BT-NG-020621-545-0287

Bramford to Twinstead Reinforcement

**Document 8.9.5 (B): Temporary and Permanent Access Technical Note
– Suffolk County Council**

**Final Issue B
February 2024**

Drawing title: **F-DAP4: The Street, Assington
 Proposed Visibility Splay
 Concept Design
 Sheet 1 of 1**

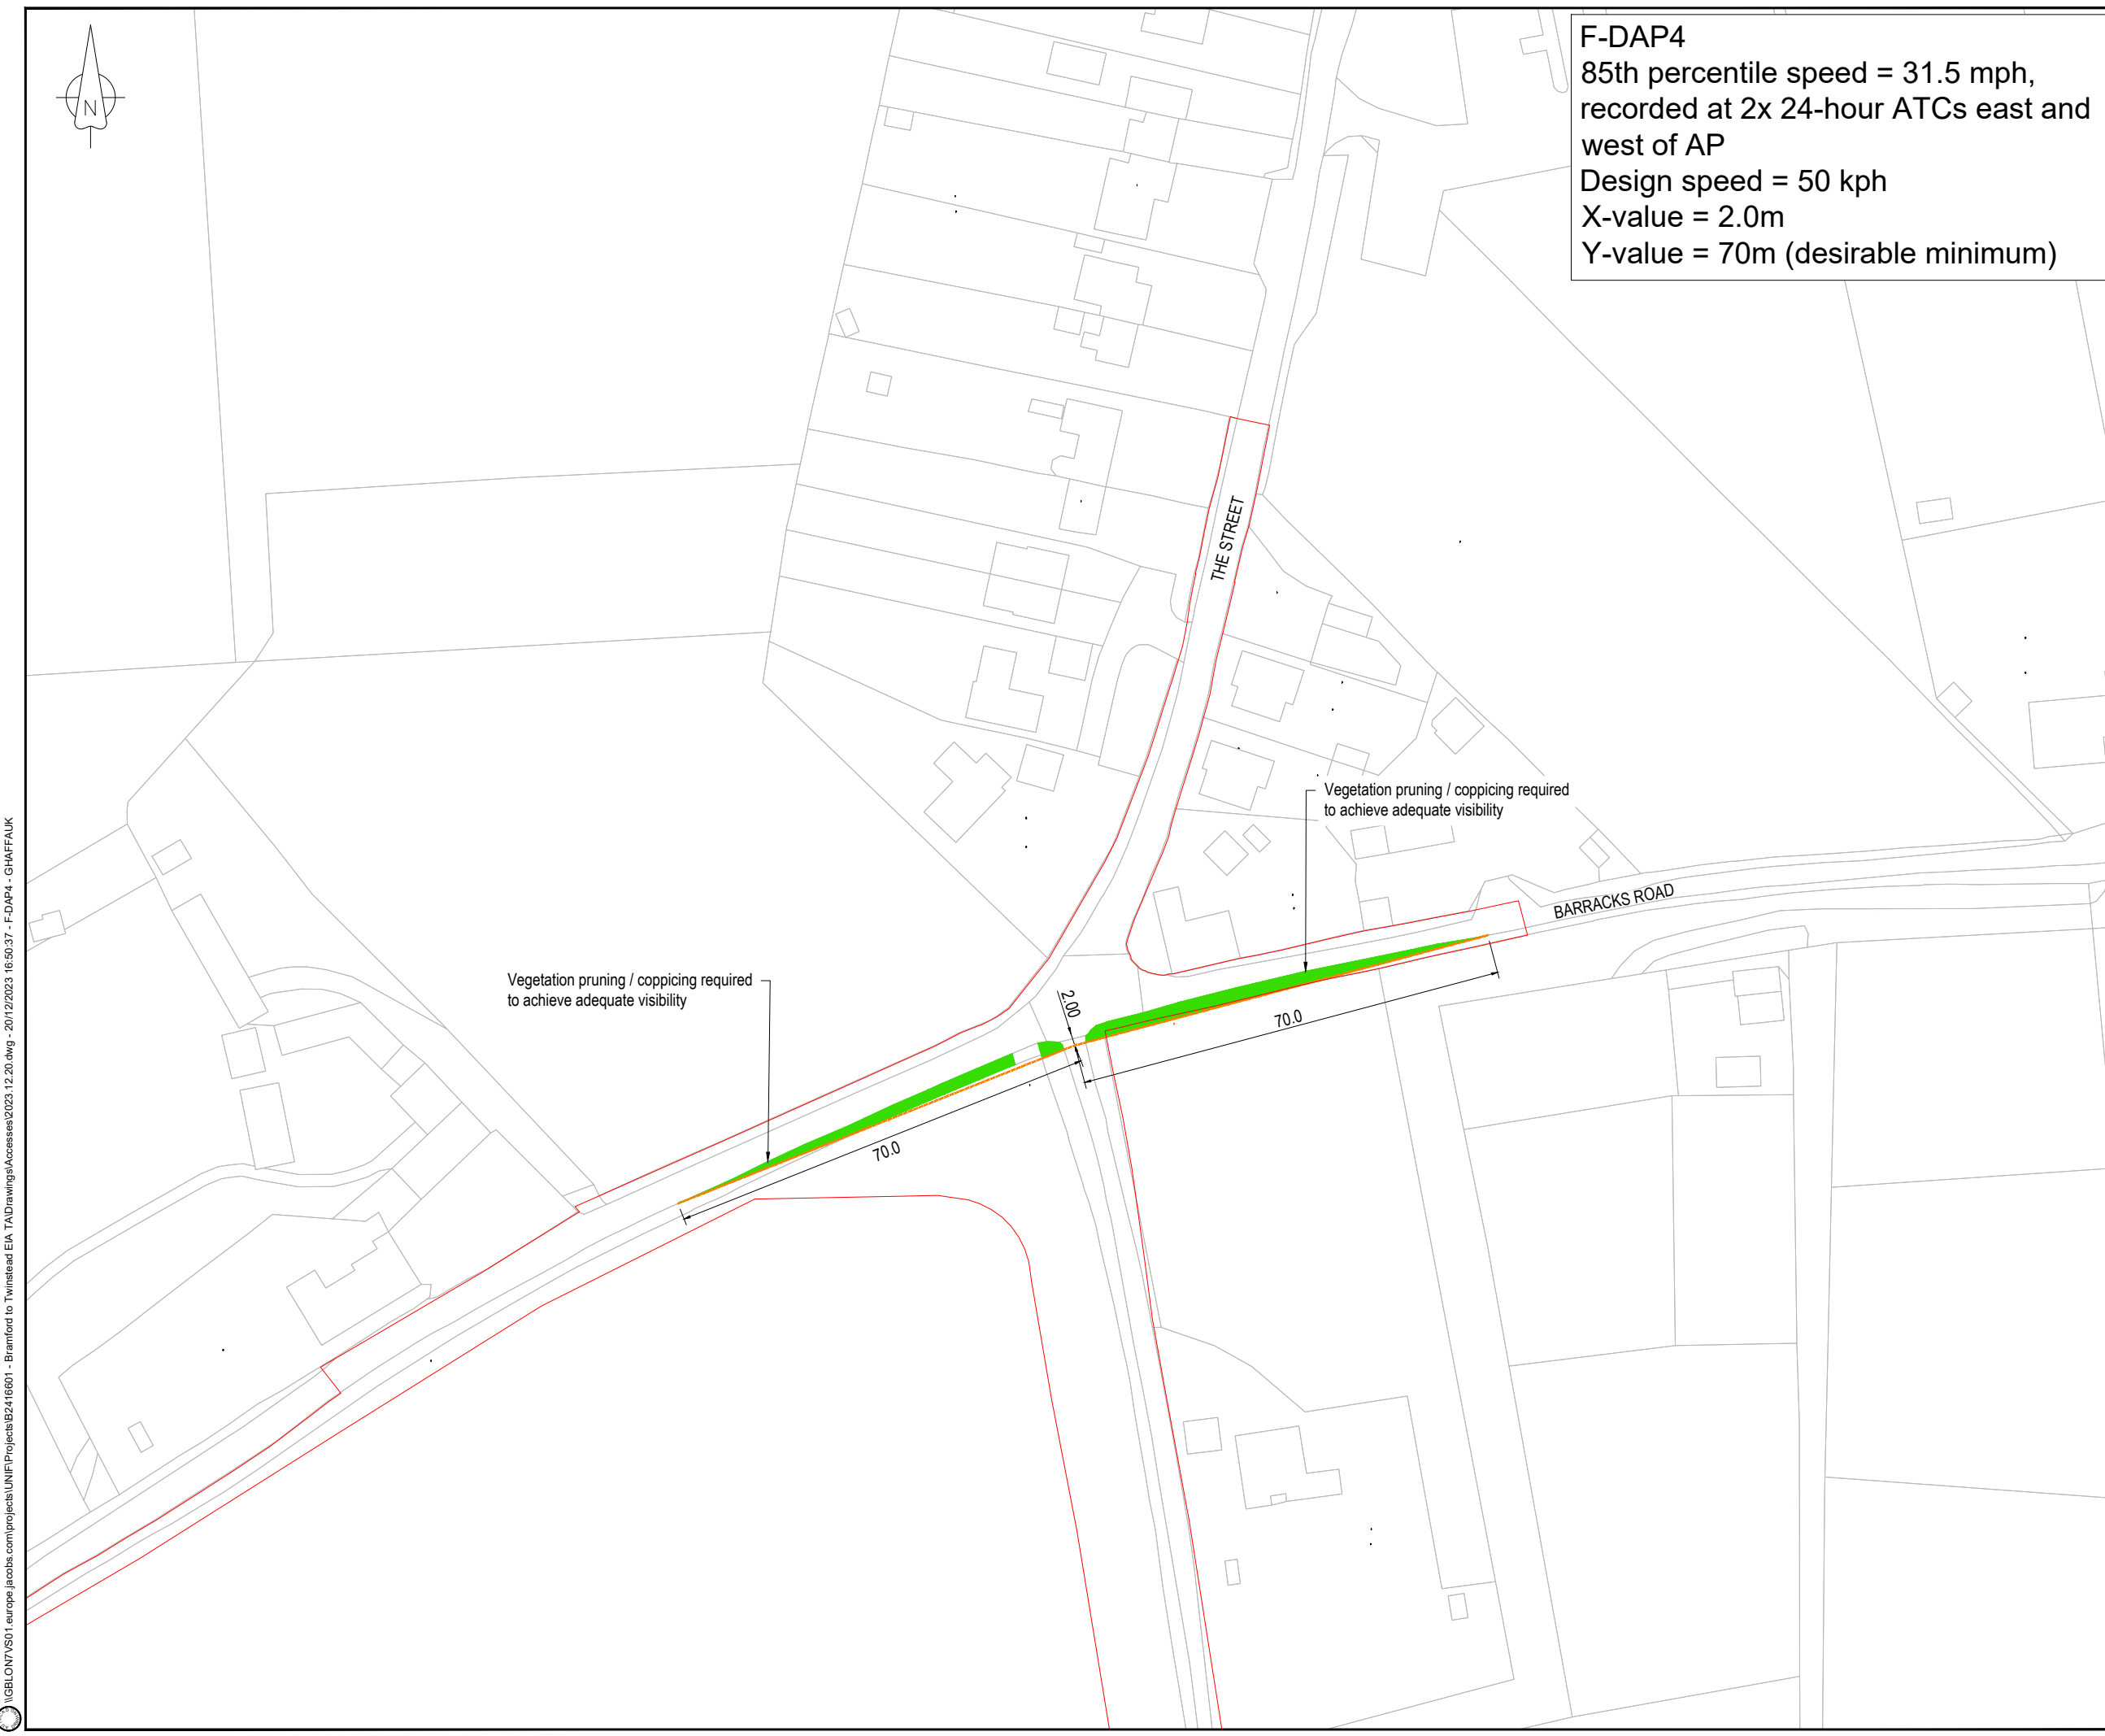
- 2.9.4 Beyond this hedge there is further vegetation along Barracks Road, which grown to the carriageway edge which would require pruning to achieve the required sightlines. The Applicant does not see this minor pruning as an impediment to the safe provision of access at this location given the powers available in Article 48 of the draft DCO [REP-003]. In addition, Requirement 8 of the draft DCO requires the approval of all vegetation to be agreed by the relevant planning authority prior to construction work commencing.

Drawing title
**F-AP4: B1068 Stoke Road, Leavenheat
 Proposed Visibility Splay
 Concept Design
 Sheet 1 of 1**

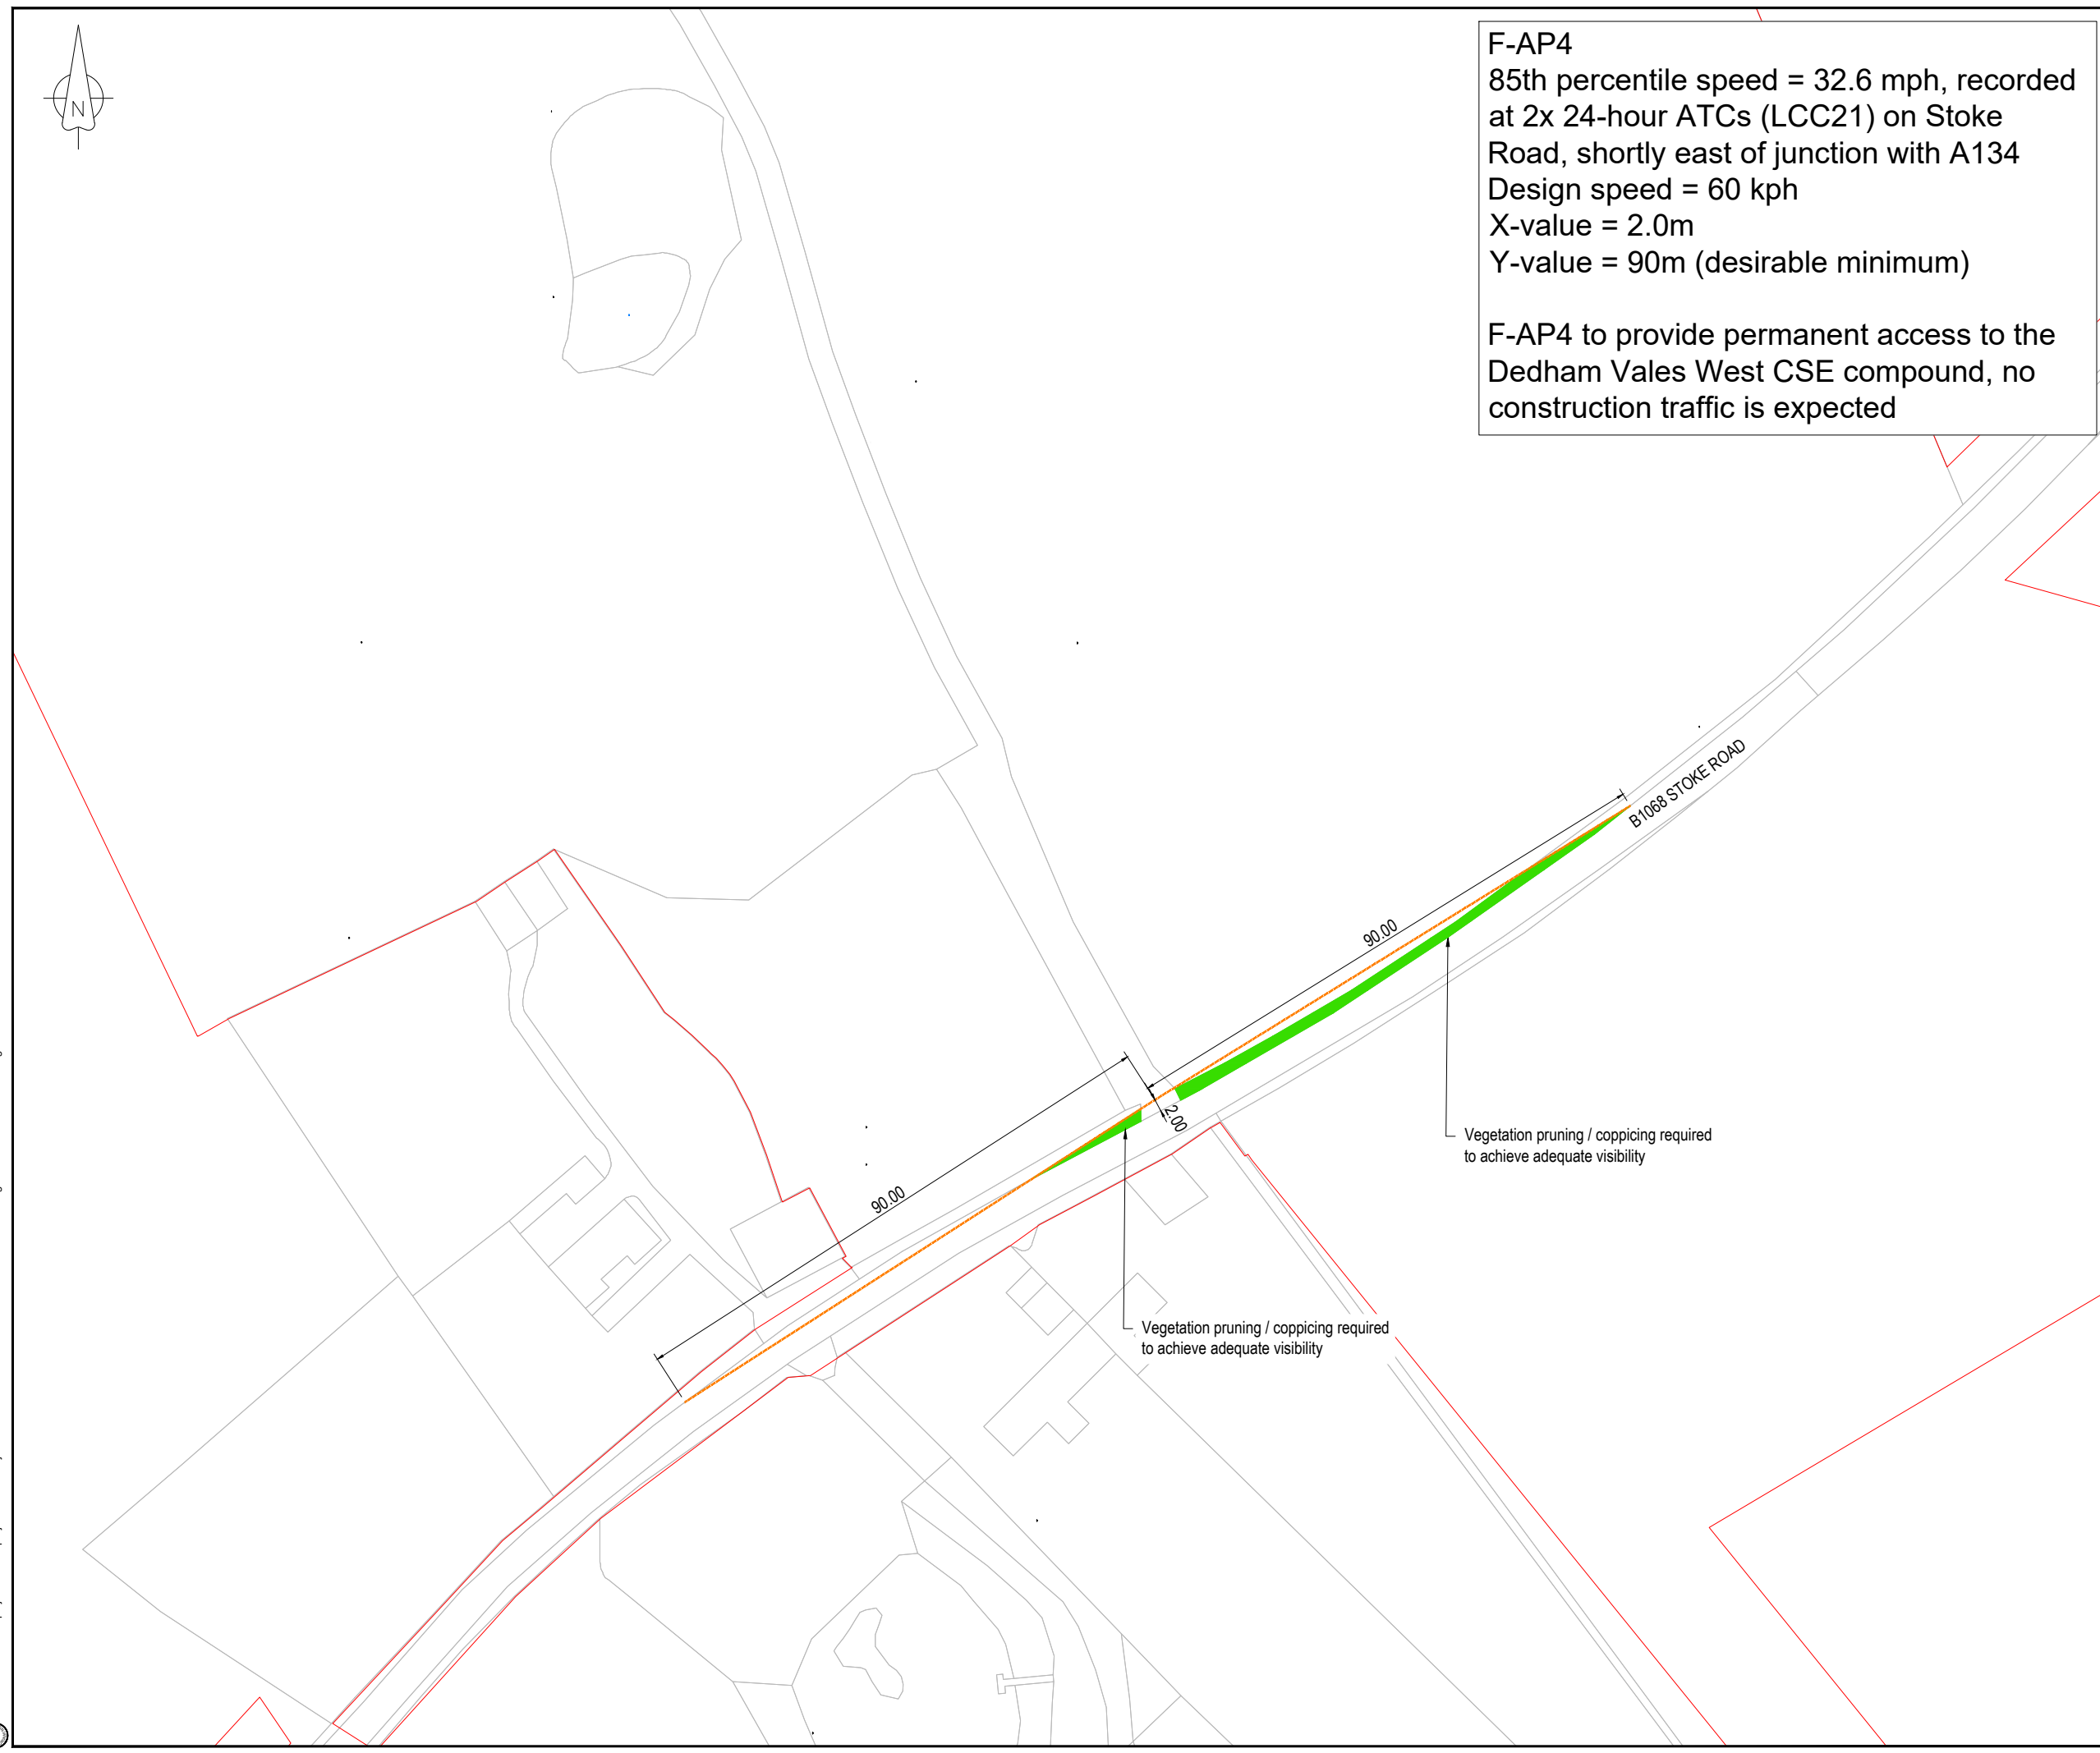
- 2.11.1 F-AP4 (Stoke Road, Leavenheath) is shown on sheet 15 of 30 on the Access Rights of Way and Public Rights of Navigation Plans [APP-012] and in Appendix A of this Technical Note. The access F-AP4 is intended to provide permanent access to the Dedham Vale West CSE compound and no construction traffic is expected.

F-AP4 to provide permanent access to the Dedham Vales West CSE compound, no construction traffic is expected
